THE TOPEKA LANDMARKS COMMISSION MEETING

A G E N D A

Thursday, April 14, 2016

Topeka Landmarks Commission
Certified Local Government
Certificate of Appropriateness
National Historic Register Project Review
TOPEKA PLANNING DEPARTMENT

CLGR16-04 by USD 501 - Topeka High School, 800 SW 10th Ave.

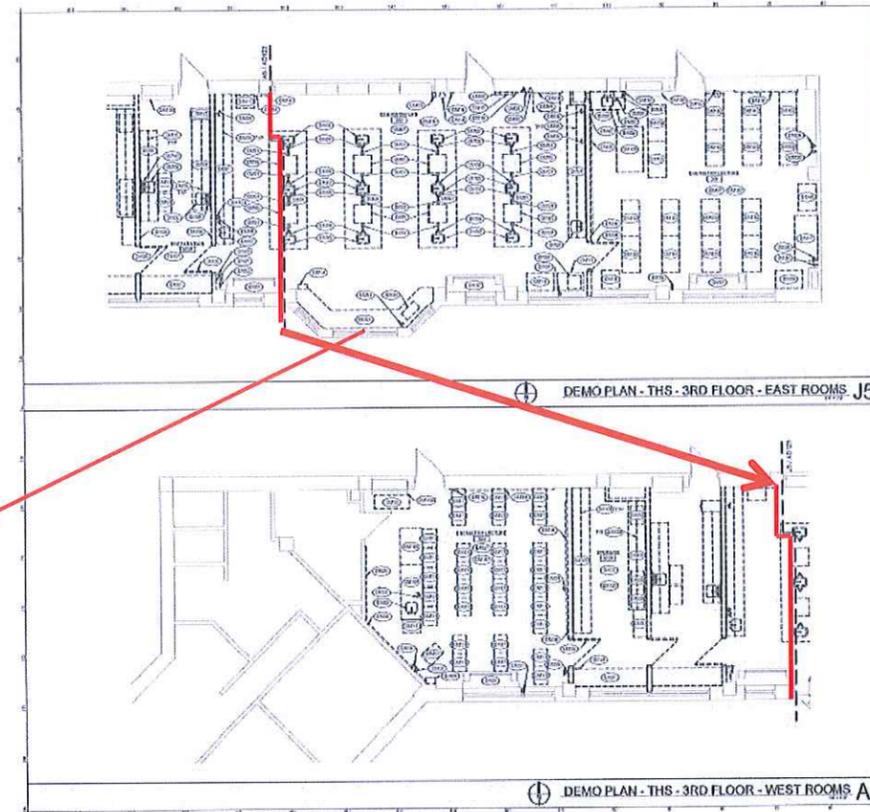
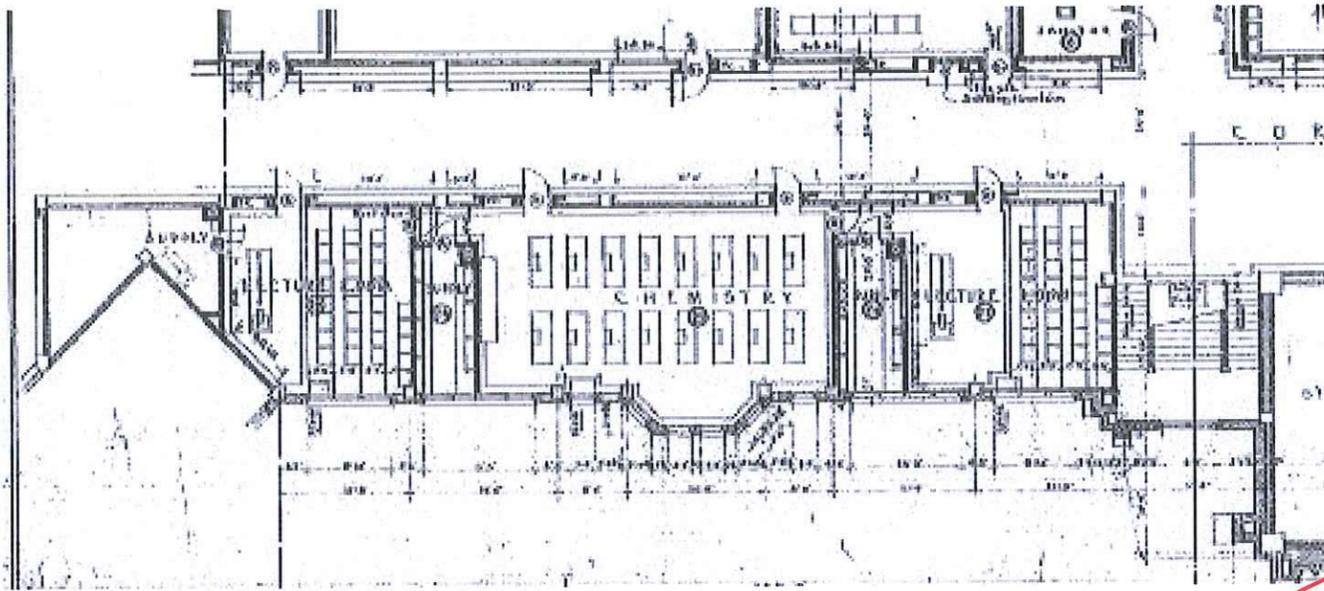
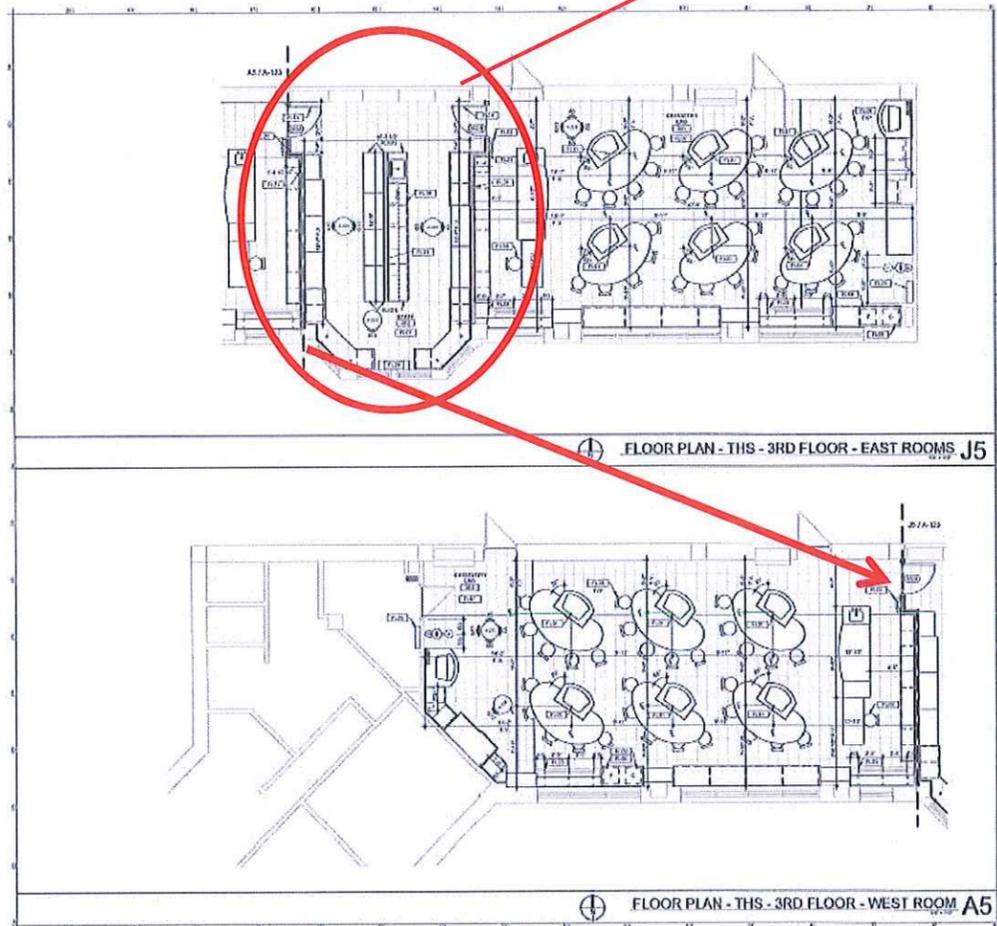
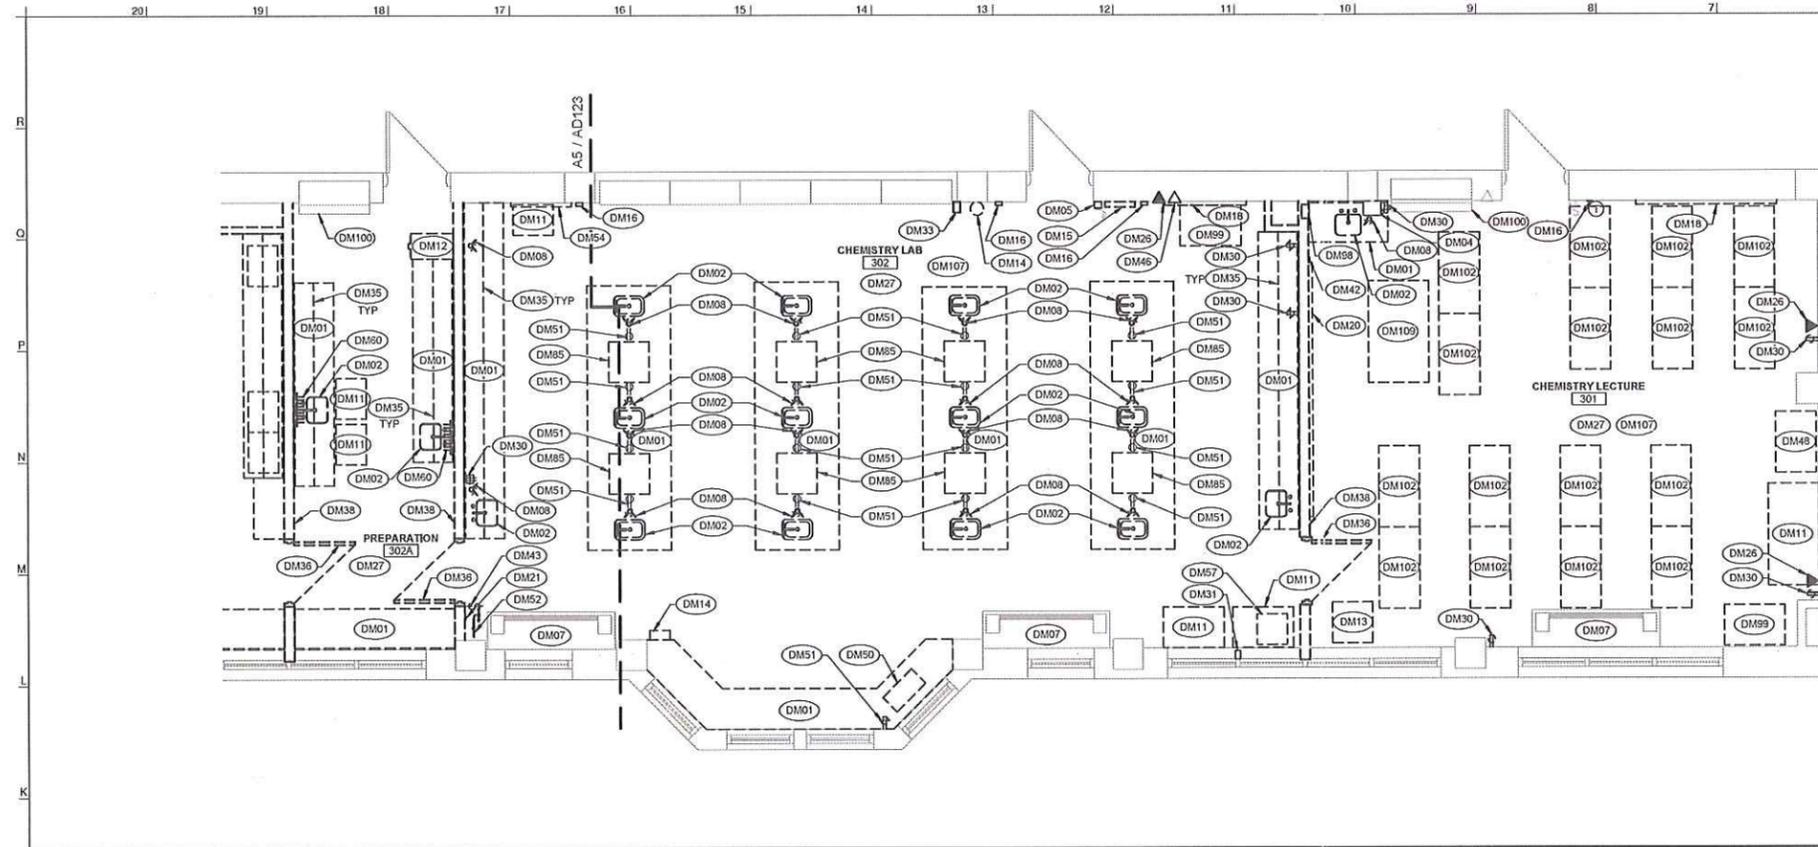
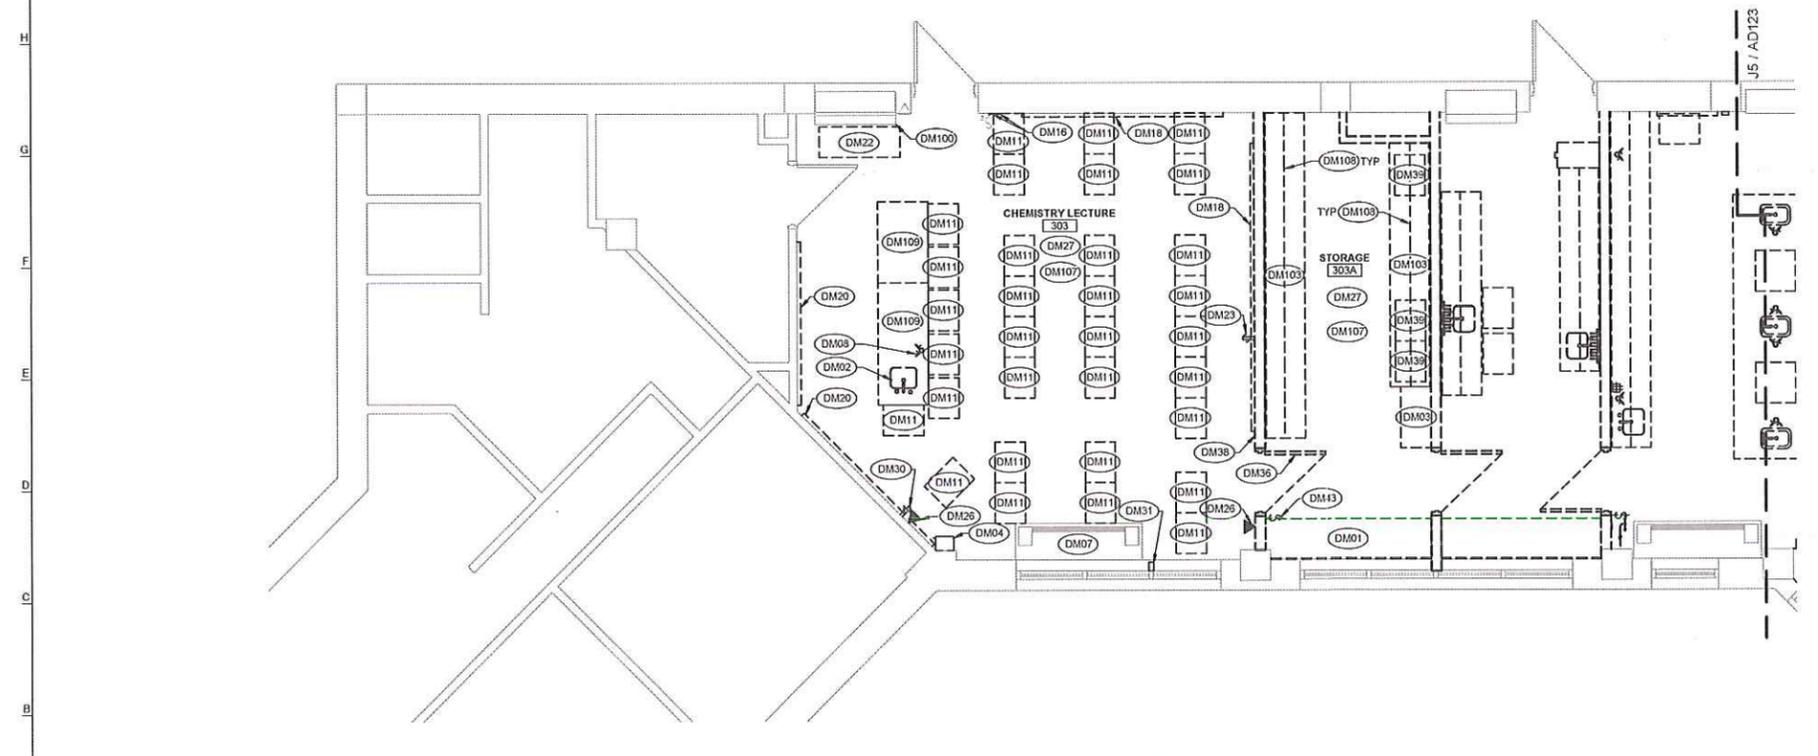
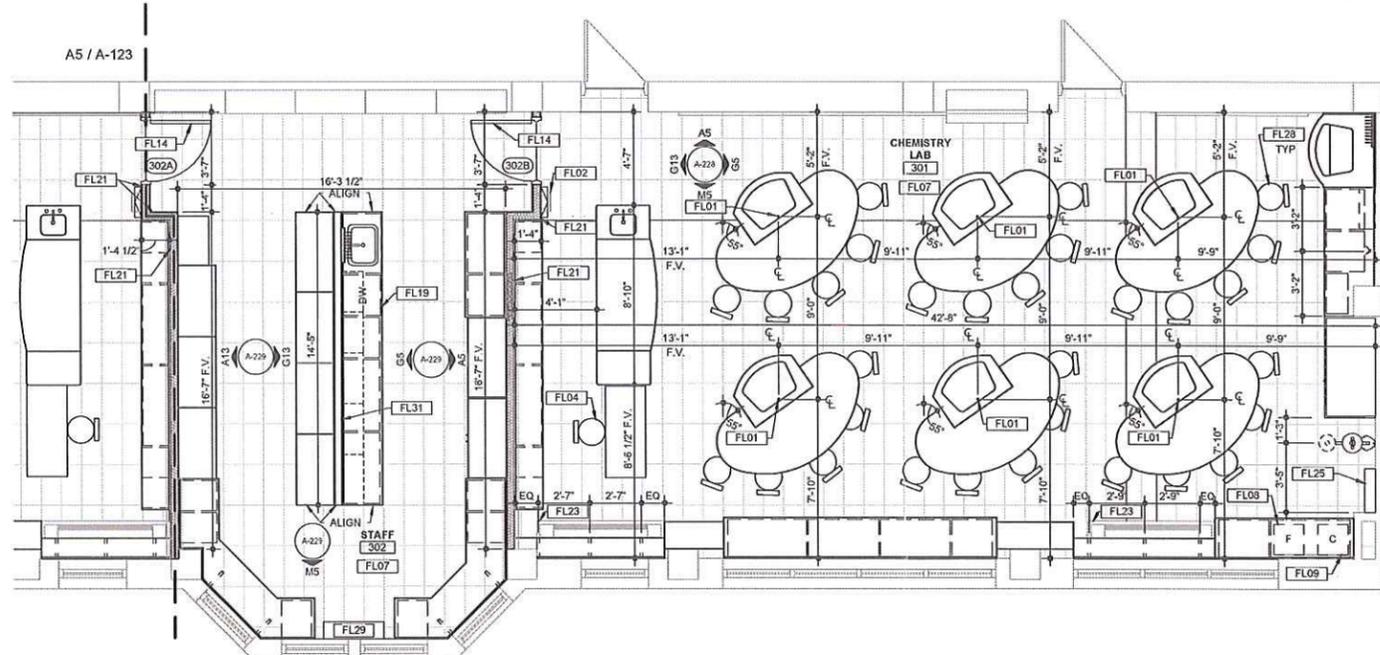
According to this guidance, the walls proposed for removal, and the construction of their replacements are located within the interior of classrooms, and are not visible from the more public space of the primary hallway, nor are they visible from any exterior entrance to the building. Additionally, the removal and replacement of each wall will avoid any substantial modification to the historic character of all affected classrooms. While it is recognized that this project does remove three original walls of the structure, this action lies within an area of secondary concern for the preservation of the building’s overall historic character, as suggested by the *National Park Service Incentives - Guide to the Federal Historic Preservation Tax Credit Incentives Program for Income Producing Properties Briefs for Historic Building Interiors*.

Analysis – All new construction related to this project will preserve the general spatial relationships relative to the classrooms and storage and prep rooms that have historically characterized the integrity of the property. Additionally, all modifications will be conducted in a manner that integrates as much of the existing historic fabric of the building, as possible, with new technologies that will ultimately result in the continued use and value of the structure for future generations.

Planning Staff Recommendation: Based upon an evaluation of the project according to the Secretary of the Interior's Standards for Rehabilitation, Staff's finding that the proposed project will **NOT** damage or destroy the historical integrity of Topeka High School.
